Product Change Notice

PCN#: EE-PCN23011

May 23, 2023

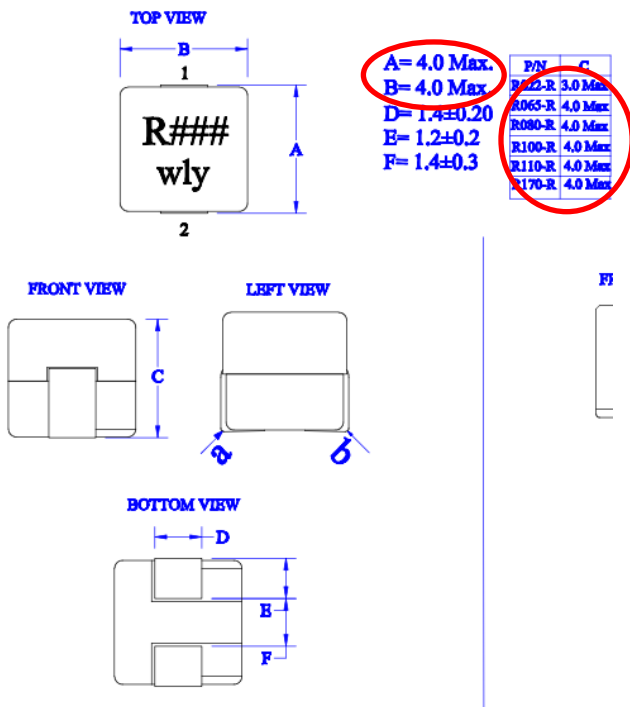
Update the FP0404R1-R datasheet to more accurately reflect dimensional measurement on the drawing by depicting measurements with tolerances rather than maximum measurements without tolerances.
